SERVICE BULLETIN SB00.20

Machines/Models: LX31/41/50 2WD **Serial Numbers:** 1000 -1409

PURPOSE: Enhance Brake Durability

PROCEDURE REQUIRED: Install Orifice and Spring, adjust the Counterbalance Valves

Figure 1

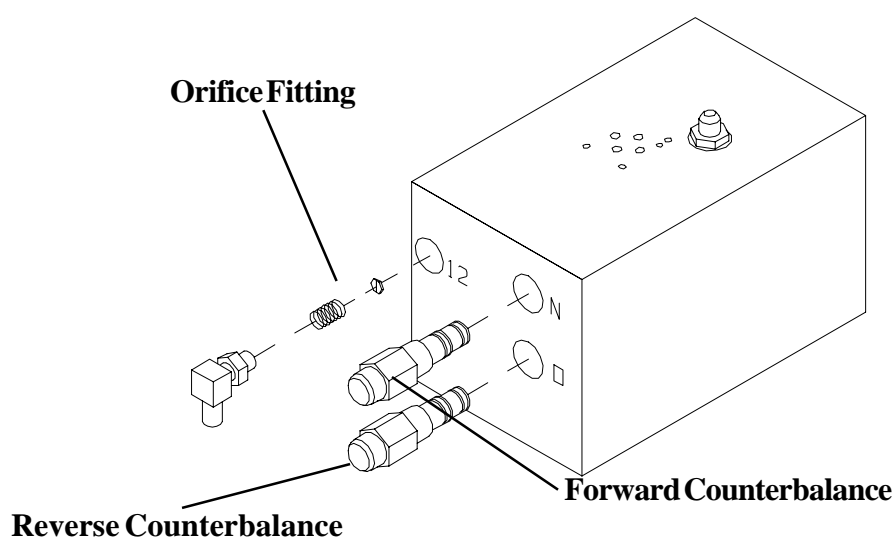
1. Locate the Forward (Reverse) Counter Balance Valve (see Figure 1).
2. Loosen the locknut.
3. Turn the valve clockwise until it gently rests against the seat.
4. Turn the valve counter clockwise 3 3/4 turns.
5. Torque the locknut to 3 Ft. Lbs (4 Nm).
6. Repeat steps 1 through 5 for the Reverse Counter Balance Valves as follows.
